MEMORANDUM

SUBJECT: Comments on the Pre-Removal Action Investigation Report and Downstream Investigation Work Plan
Crawford Street South Site, Portland, Oregon
ECSI # 2363
January 19, 2026

FROM: Laura Hanna, RG, Remedial Project Manager *Laura Hanna*
Superfund and Emergency Management Division, EPA

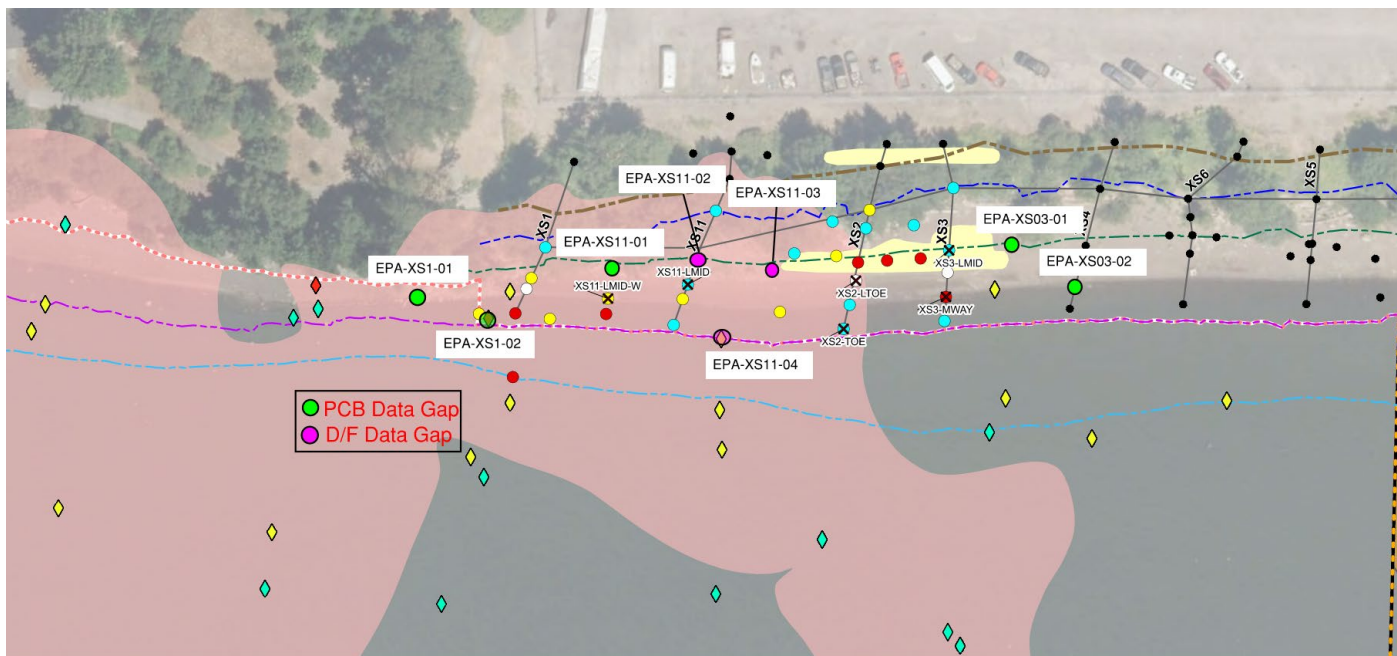
4. **Section 7.0 Work Plan for Additional Downstream Definition of PCBs and PeCDD/TCDD, General:** To address existing data gaps and characterize the horizontal and vertical extent of PCB and Dioxin/Furan contamination between the Ordinary Low Water (OLW) elevation (7.2’ NAVD88) and Mean High Water (MHW) elevation (13’ NAVD88) within the Crawford Street Project Area, EPA proposes collection of additional sediment/riverbank samples during Crawford Street’s Downstream Investigation as presented on the following figure:

The sampling intervals for the proposed additional samples and/or archiving samples are presented on the table below:

EPA Proposed Sample	Proposed Depth (ft)	Proposed Sampling Intervals (1-ft intervals)	Sample Scope
EPA-XS1-01	10	0 to 10	Laterally delineate the extent of deeper PCB Exceedances at XS1-TOE-W
EPA-XS1-02	10	4 to 10	Revisit XS1-TOE-W to Delineate DOC at XS1-TOE-W and XS1-TOE
EPA-XS11-01	10	0 to 10	Delineate DOC at MHW boundary
EPA-XS11-02	10	0 to 10	Delineate DOC at MHW boundary
EPA-XS11-03	10	0 to 10	Delineate DOC at MHW boundary
EPA-XS11-04	10	0 to 10	Delineate DOC at RB-27 since XS11-LTOE is not being revisited
EPA-XS03-01	5	0 to 5	Lateral and Vertical delineation of PCB exceedance at SC-143a towards MHW
EPA-XS3-02	5	0 to 5	Lateral and Vertical delineation of PCB exceedance at SC-143a towards XS 4
